PG&E Letter DCL-14-014

Docket No. 50-275, OL-DPR-80
Docket No. 50-323, OL-DPR-82
Diablo Canyon Units 1 and 2
Pacific Gas and Electric Company's Second Six-Month Status Report in Response to March 12, 2012, Commission Order Modifying Licenses with Regard to Requirements for Mitigation Strategies for Beyond-Design-Basis External Events (Order Number EA-12-049)

Pacific Gas and Electric Company's Second Six-Month Status Report for the Implementation of NRC Order EA-12-049

Figure 1
 Deployment Routes
 Warehouse B BDB Storage Facility

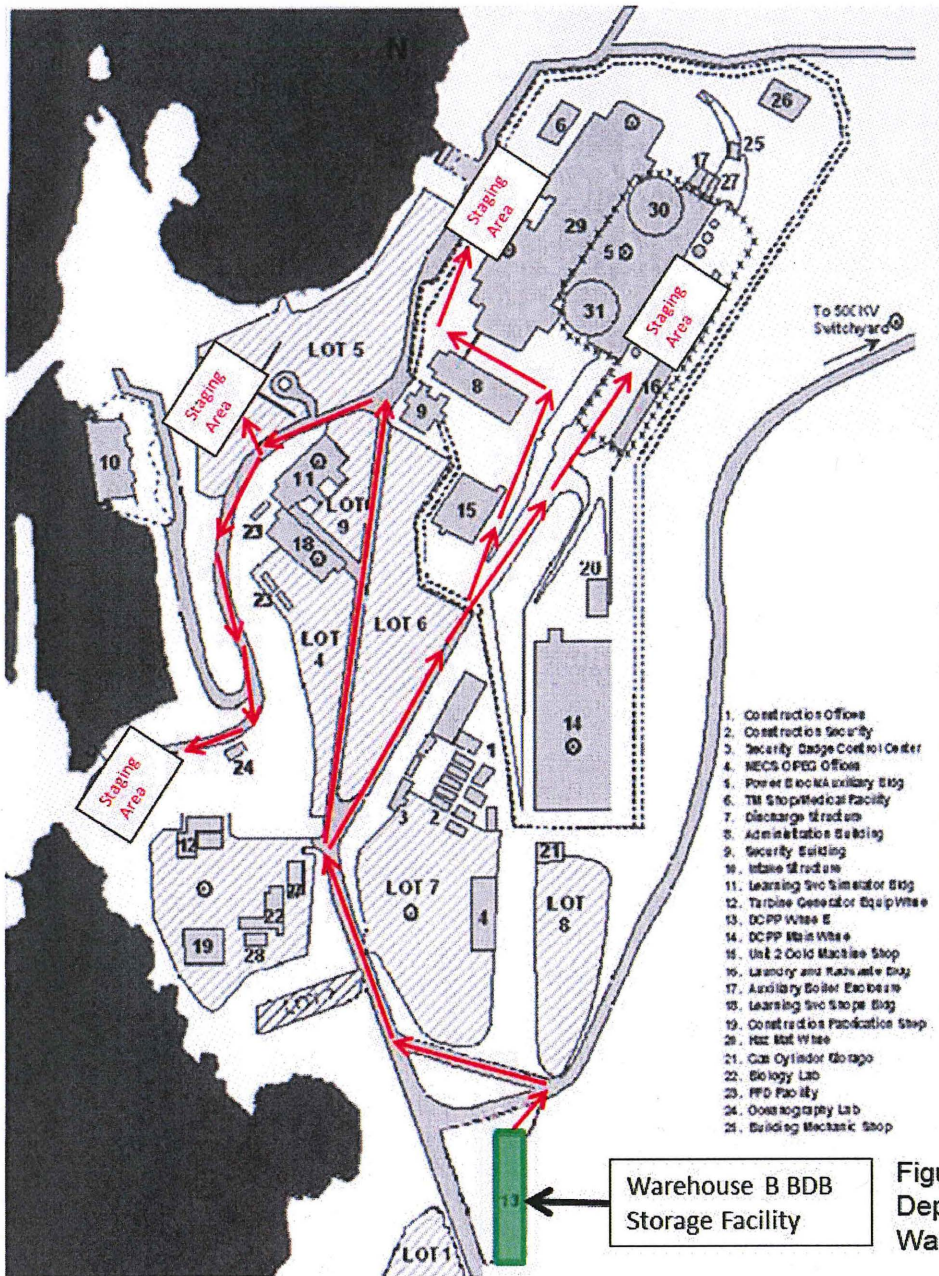
- (1) Retitled Figure 1 in contents to read “Deployment Routes – Warehouse B BDB Storage Facility”
- (2) Figure 1 Revisions:
 - (a) Removed Area 10 BDB Storage Facility and associated deployment routes
 - (b) Added Warehouse B BDB Storage Facility and associated deployment routes
 - (c) Added fourth staging area (for staging of the dewatering pumps)

See Attachment A for the revised figure.
